# ROAD SAFETY AUDIT EXISTING CONDITIONS

Kialla West Primary School, Kialla West

APPENDIX 1 – SITE PHOTOGRAPHS

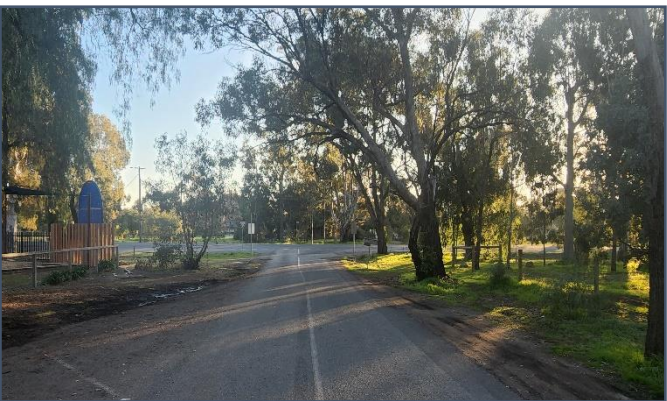
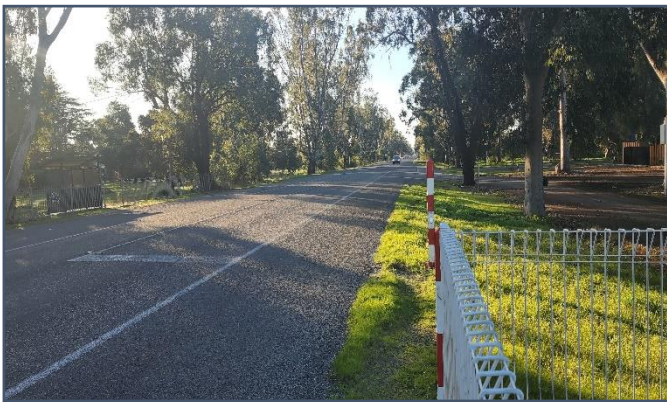
No.#	SAFETY CONCERN	RISK	PHOTO	CLIENT RESPONSE
1	<p>Vehicles exiting Kialla West Primary School are doing so at a Y-angle resulting in reduced visibility to oncoming traffic as a result of geometry and some existing signage, creating an increased risk of a cross-traffic type crash. In addition, most exiting vehicles turn right towards Shepparton which increases the exposure risk of collision with through vehicles.</p>	<p><b>MED (FSI)</b></p>		<p>Accepted:</p> <p><input type="checkbox"/> Yes <input type="checkbox"/> No</p> <p>Comments:</p>
<b>RECOMMENDATION</b>		<b>SAFE SYSTEM ANALYSIS</b>		
<p>It is recommended that the exit point to the western carpark is closed, and the space is used solely as a staff carpark, with all pick up and drop off movements redirected to Cemetery Road.</p>		<p><b>Safety Element addressed</b></p> <p><input checked="" type="checkbox"/> Exposure</p> <p><input checked="" type="checkbox"/> Likelihood</p> <p><input type="checkbox"/> Severity</p>	<p><b>Safe System Treatment Alignment</b></p> <p><input type="checkbox"/> <b>Primary Treatment</b></p> <p><input checked="" type="checkbox"/> <b>Step Towards</b></p> <p><input type="checkbox"/> <b>Supporting</b></p> <p><input type="checkbox"/> <b>Non Safe System treatment</b></p>	<p><b>Predominant Crash Risk Addressed</b></p> <p><input type="checkbox"/> Run off road</p> <p><input type="checkbox"/> Head-On</p> <p><input checked="" type="checkbox"/> Intersection</p> <p><input type="checkbox"/> Pedestrians</p> <p><input type="checkbox"/> Cyclists</p> <p><input type="checkbox"/> Motorcycle</p>

No.#	SAFETY CONCERN	RISK	PHOTO		CLIENT RESPONSE
3	<p>Uncontrolled turning movements out of Cemetery Lane are considered to pose an increased risk of intersection type crashes. The typical vehicle queueing present on Cemetery Lane may result in driver impatience and thus unsafe manoeuvres when exiting. Under the proposed conditions outlined in the previous recommendation, an impatient driver who feels they have been queueing for an undesirable time may perform a right turn before the pedestrian phase triggers and provides a clear opportunity.</p>	<p><b>MED (FSI)</b></p>			<p>Accepted:  <input type="checkbox"/> Yes                      <input type="checkbox"/> No  Comments:</p>
<b>RECOMMENDATION</b>		<b>SAFE SYSTEM ANALYSIS</b>			
<p>Alignment with Safe System principles would require installation of traffic signals in conjunction with raised platforms (or a roundabout) at the Cemetery Lane intersection so that turning movements onto Shepparton-Seymour Road only occur during the designated phase. Nevertheless, the speed on Shepparton-Seymour Rd is too high for the raised platforms to be considered. Hence, installation of traffic signals would be more appropriate.</p>		<b>Safety Element addressed</b>	<b>Safe System Treatment Alignment</b>	<b>Predominant Crash Risk Addressed</b>
